Energy West Mine Company

Trail Mountain Mine
C/015/0009

Mid – Term Review

**Subject: Response to Deficiencies in the Trail Mountain Mine, Mid-Term Review,
PacifiCorp, Trail Mountain Mine, C015/0009, Task ID #2878, Emery County,
Utah**

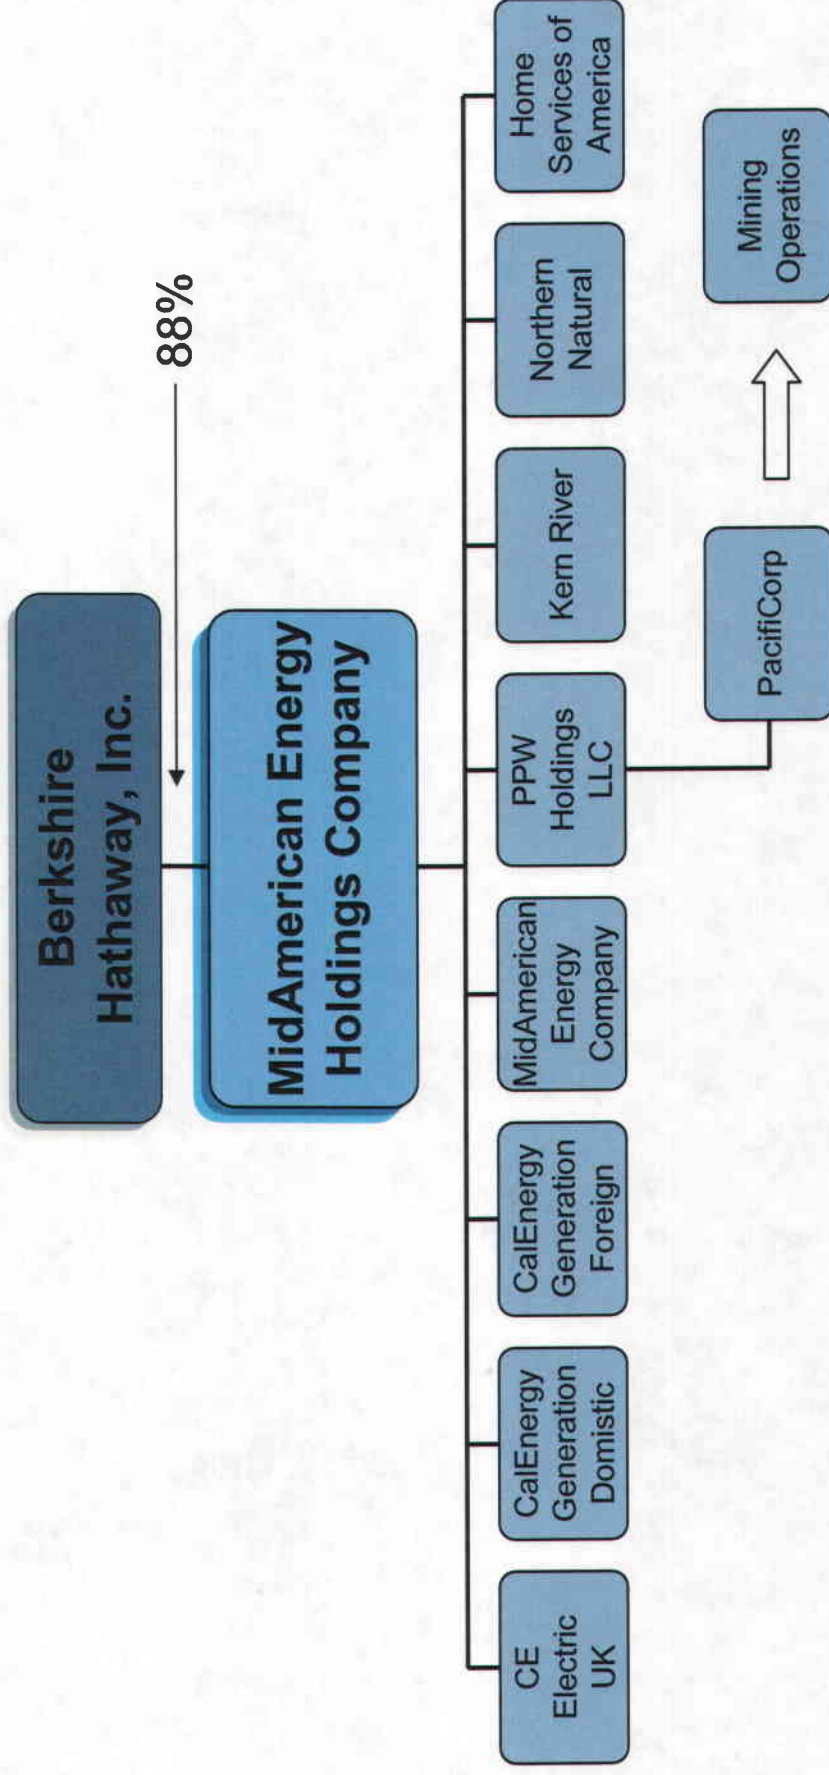
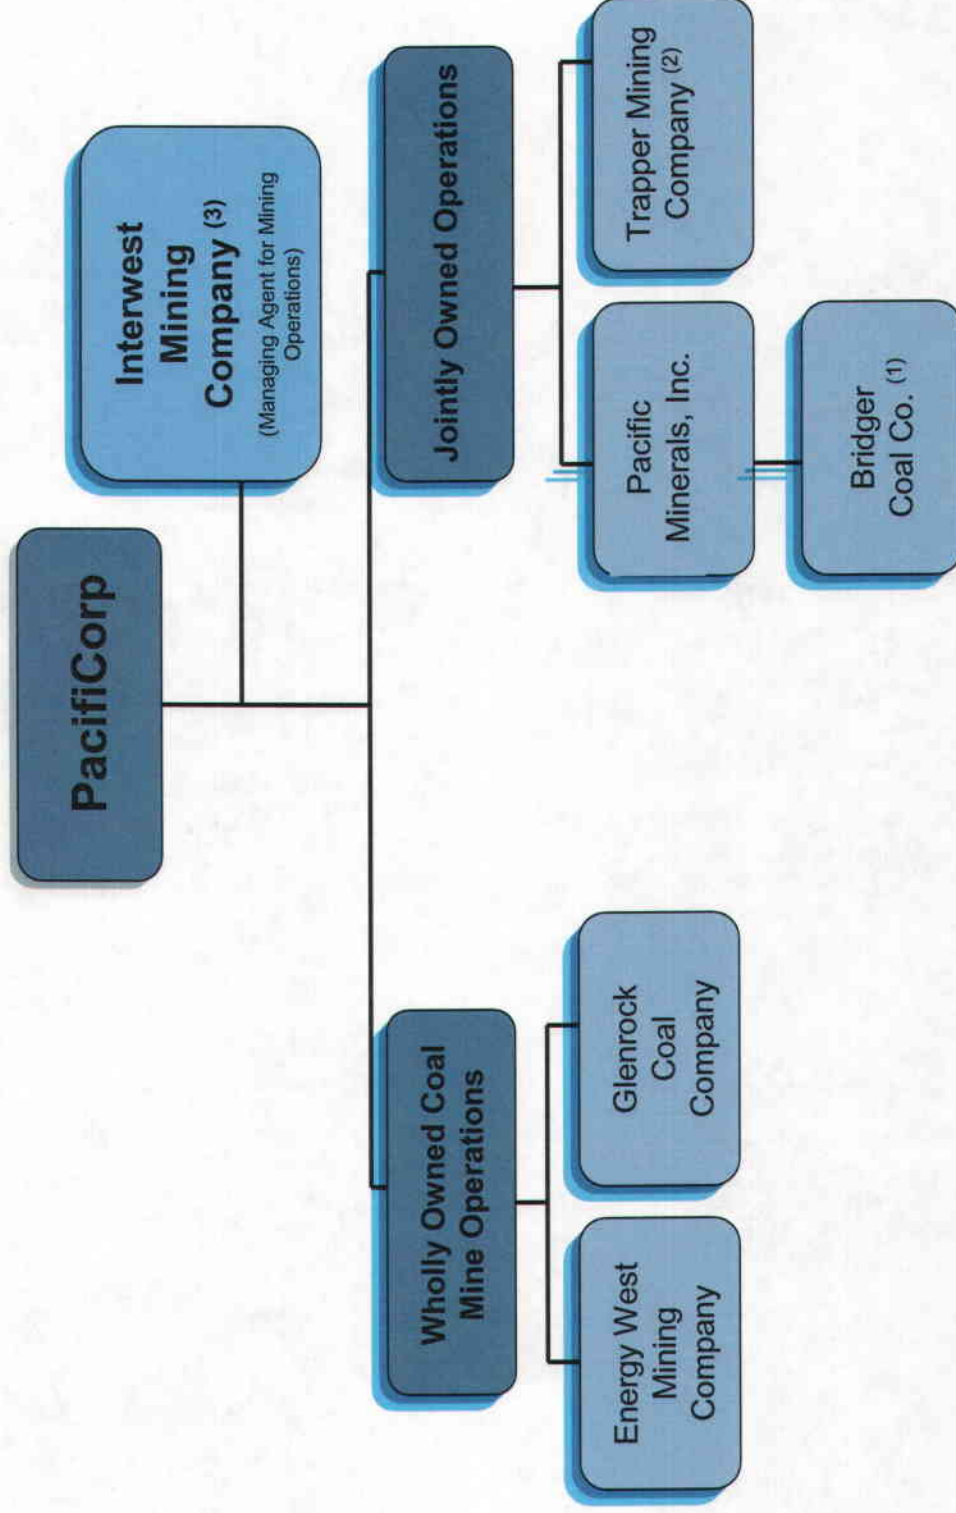
- Show the relationship of all parent entities and affiliates on an ownership family tree. (PB)
 - *See the attached illustration depicting the overall corporate structure.*
